Certificate of Appropriateness

Scooter's/Cherry on the Top request a certificate of appropriateness for work at 151 No. 8th Street in the Haymarket Landmark District.

EAST ELEVATION

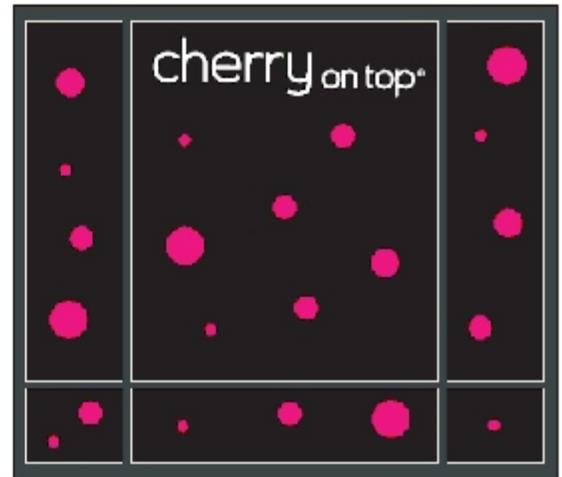
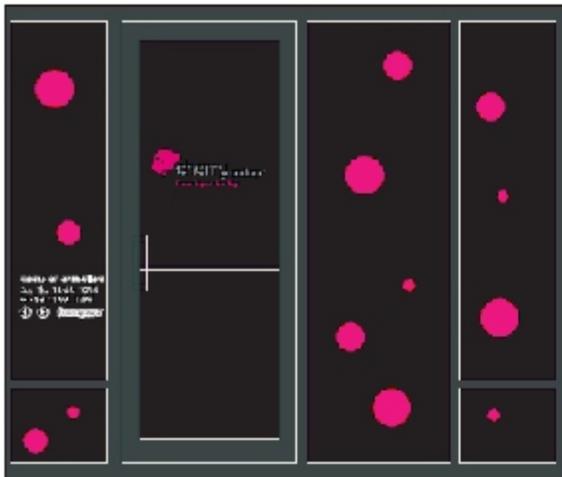
The two shops propose to install black, triangular section awnings on each opening—five on 8th Street and three on P Street. The awnings would be inscribed in the valance area with "Scooter's" or "Cherry on the Top," alternating between the names. The valance area is 14" tall; the inscriptions are somewhat shorter.

Inscribed awnings are a typical Haymarket sign type and are consistent with the sign guidelines. Confining the inscriptions to the valances keeps their size relatively modest. Alternating the names conveys that the two businesses are closely affiliated. A more subjective judgement is whether repeating the names

on every awning contributes to the lively commercial atmosphere of Haymarket, or is overdone. My recommendation is that it approaches that line, but does not cross it, mostly due to the size of the inscription compared to the overall awning.

Recommended action: Approval of a certificate of appropriateness for the inscribed awnings;
denial of a certificate for the window graphics.

A related proposal would install pink circles—cherries—in the south windows. (The white inscription in the north window represents the previously approved neon.) These circles are “signs” in the definition

of the Lincoln zoning code in that they are clearly intended to call attention to a specific business and in this instance relate closely to the business logo. I would recommend against this part of the proposal as “over-signing” the storefront windows and establishing an undesirable precedent in terms of other business logos.
